## ADDENDUM NO. 1

PROJECT: Saline Area Schools – 2022 Bond Program – MS Rec Complex  
 DESCRIPTION: Addendum No.1  
 BID PACKAGE RELEASE NUMBER: BP #3

1. ADDENDUM No. 1, November 20<sup>th</sup>, 2024 as issued by Kingscott (Attached)
2. Bid Package T4 Draft Drawings, October 22<sup>nd</sup>, 2024 - Saline Middle School Rex Complex as issued by Barton Malow (For Reference Only)

SHEET NO.  
**C3.3**

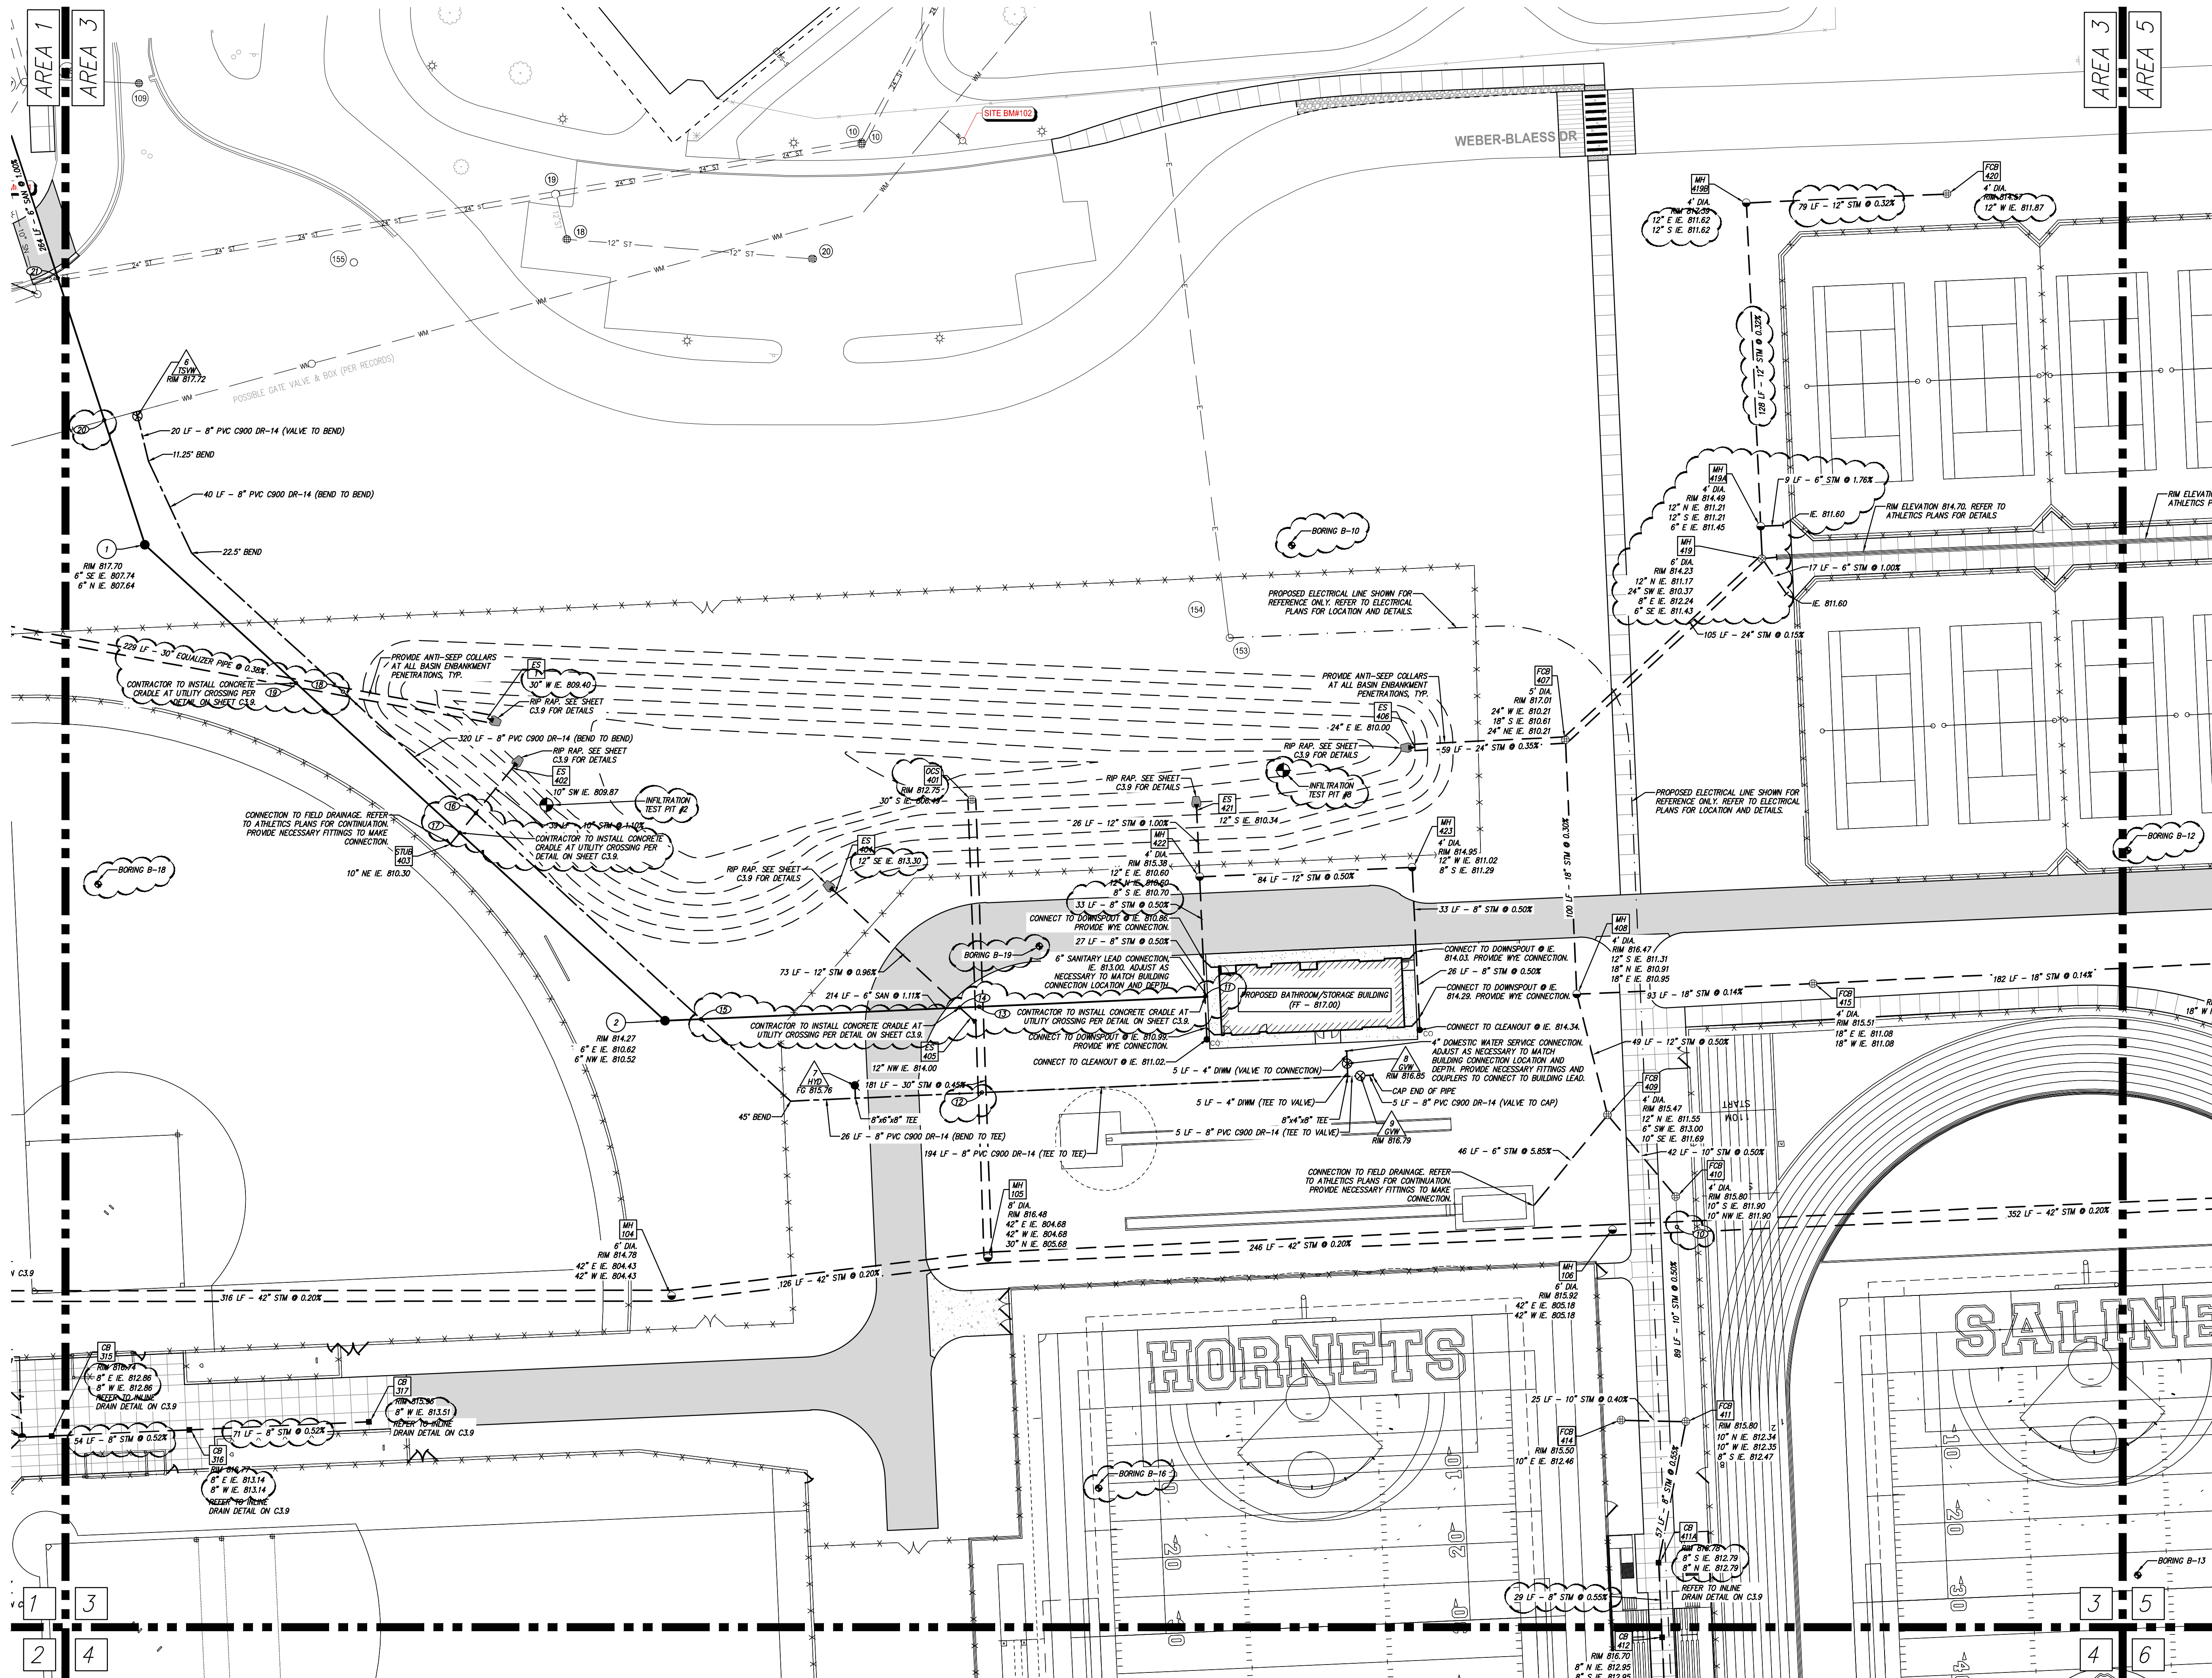
**Item No. 24: Revised inverts, pipe slopes, pipe and structure sizes, and pipe material on sheet C3.3.**

**Item No. 25: Added infiltration test pits on sheet C3.3.**

**Item No. 26: Added boring locations on sheet C3.3.**

**Item No. 27: Added utility crossing number(s) and crossing table(s) on sheet C3.3.**

**Item No. 28: Added and revised concrete cradle note(s) on sheet C3.3.**

**Item No. 29: Revised rim elevation for standpipe on sheet C3.3.**

**Item No. 30" Added MH419A on sheet C3.3.**

SHEET NO.  
**C3.4**

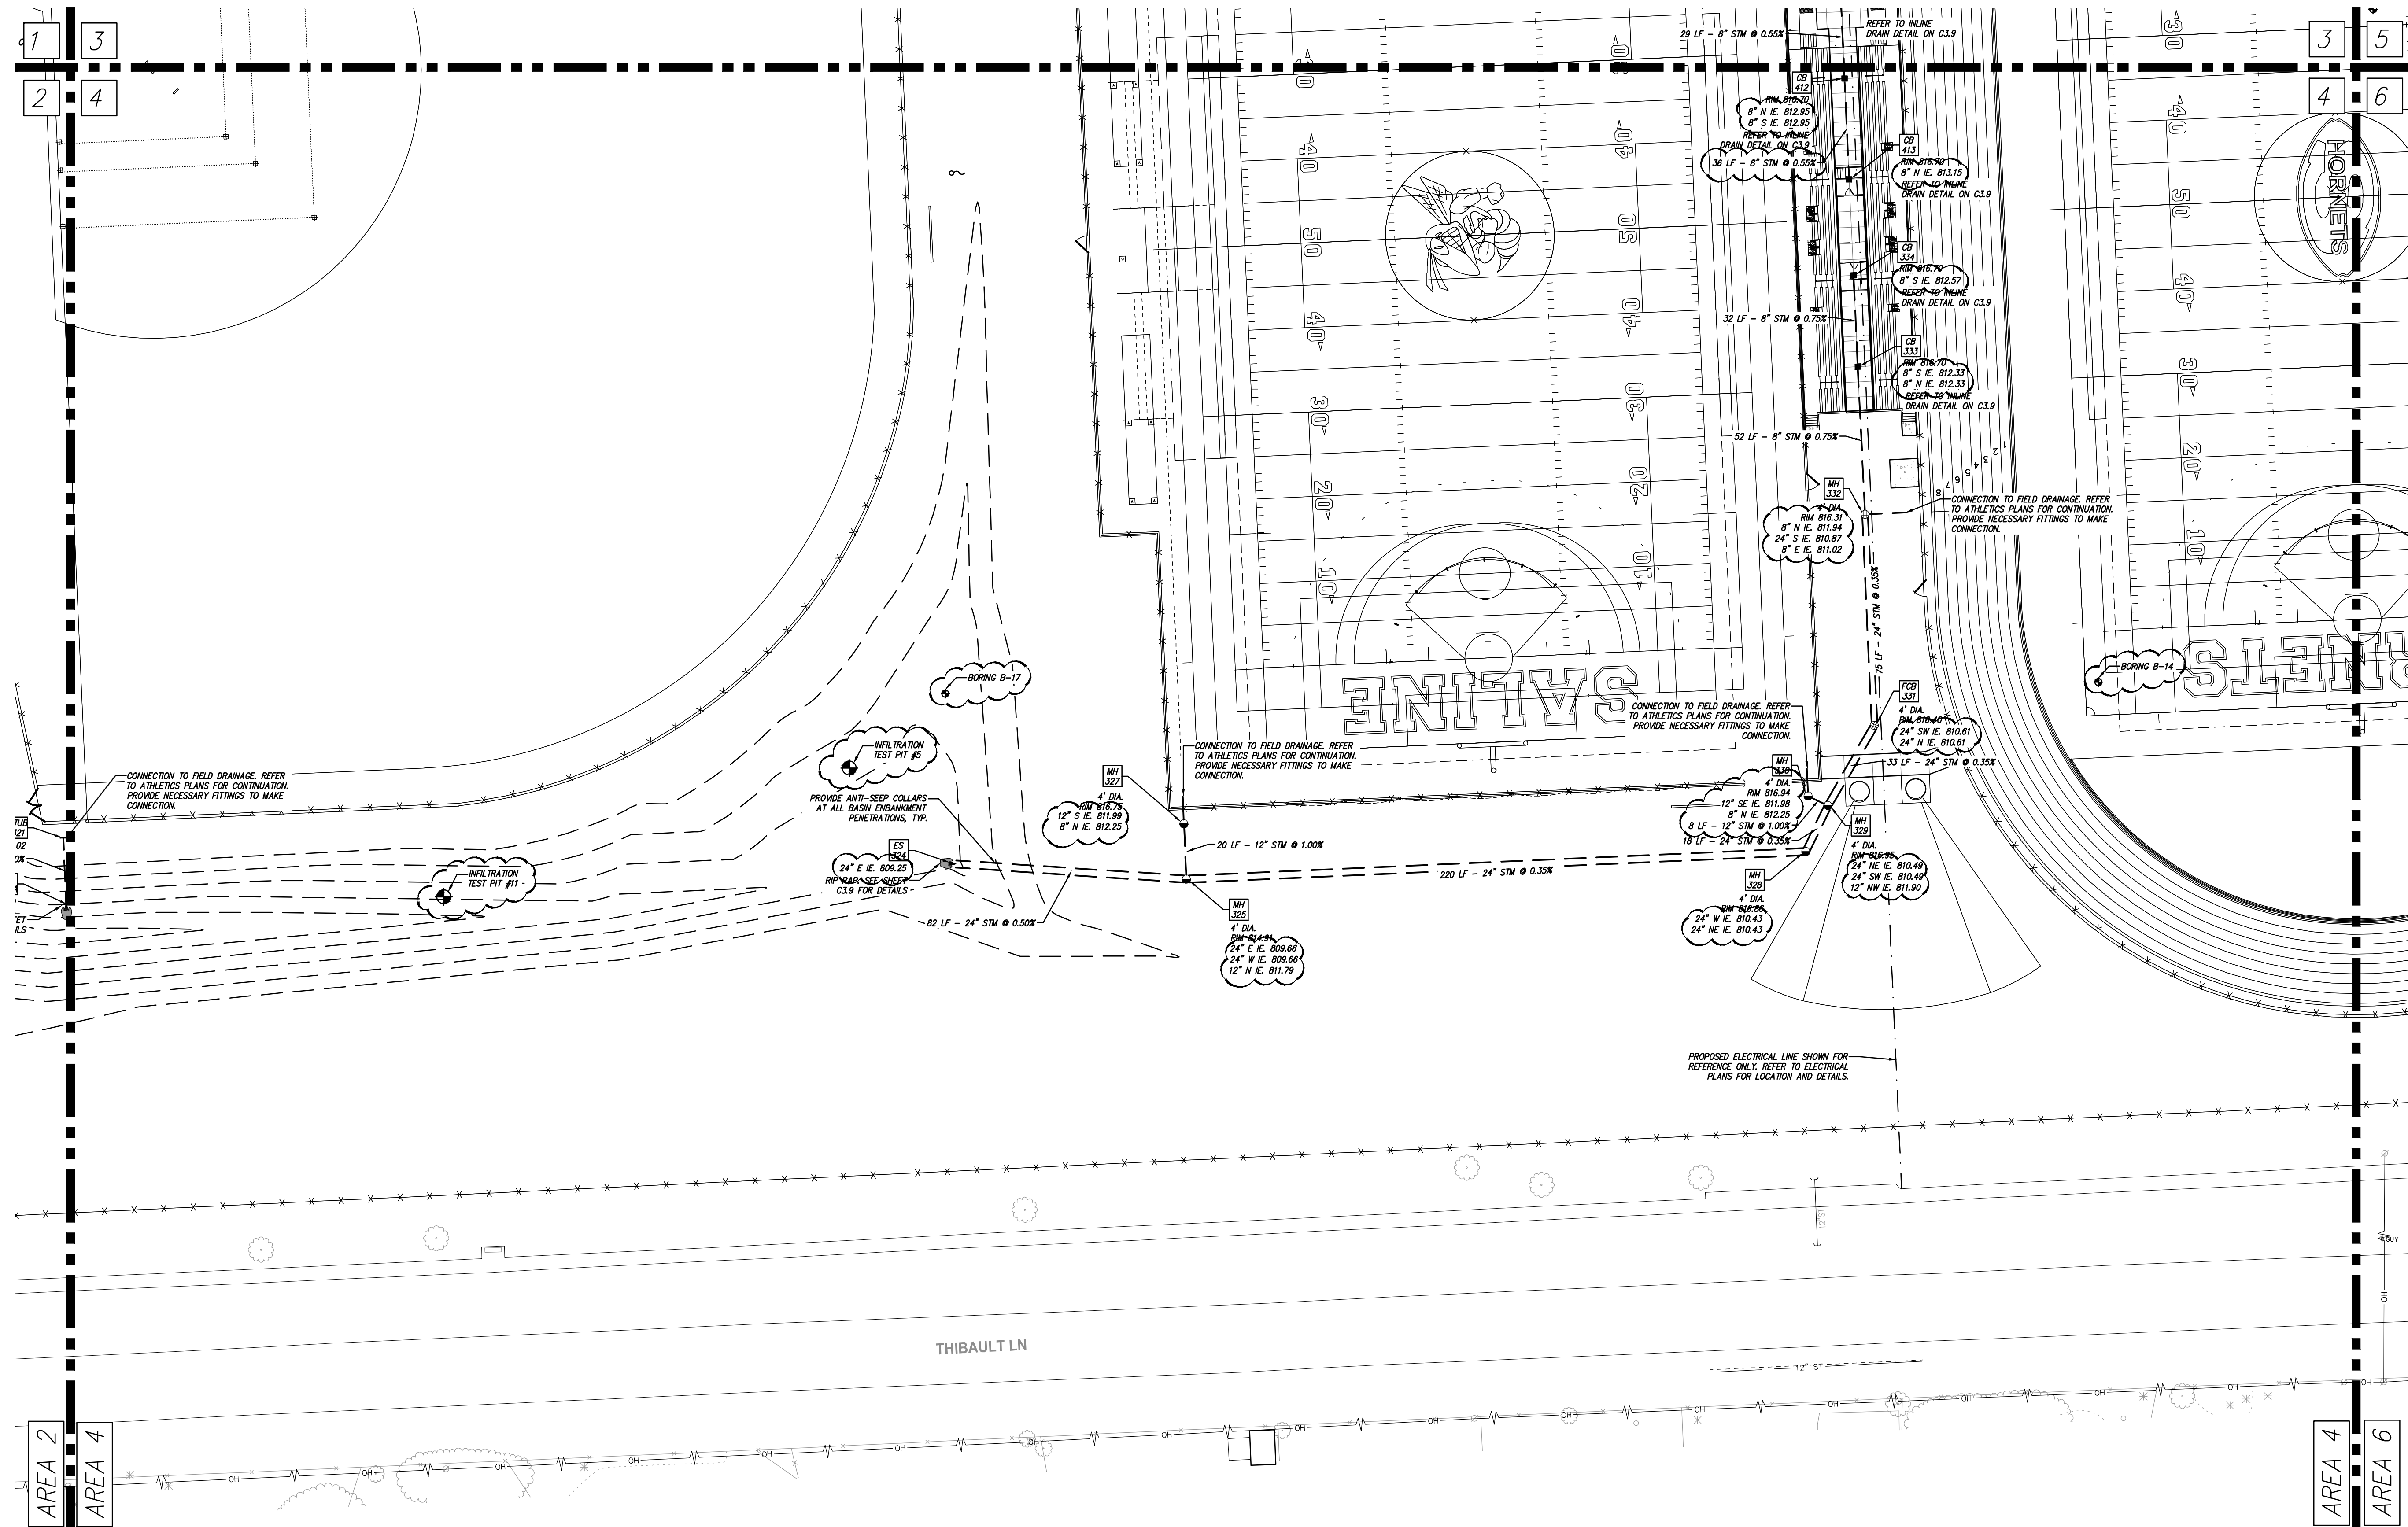
**Item No. 31: Revised inverts, pipe slopes and pipe sizes on sheet C3.4.**

**Item No. 32: Added infiltration test pits on sheet C3.4.**

**Item No. 33: Added boring locations on sheet C3.4.**

**Item No. 34" Removed ES 322 and associated pipe and stub on sheet C3.4.**
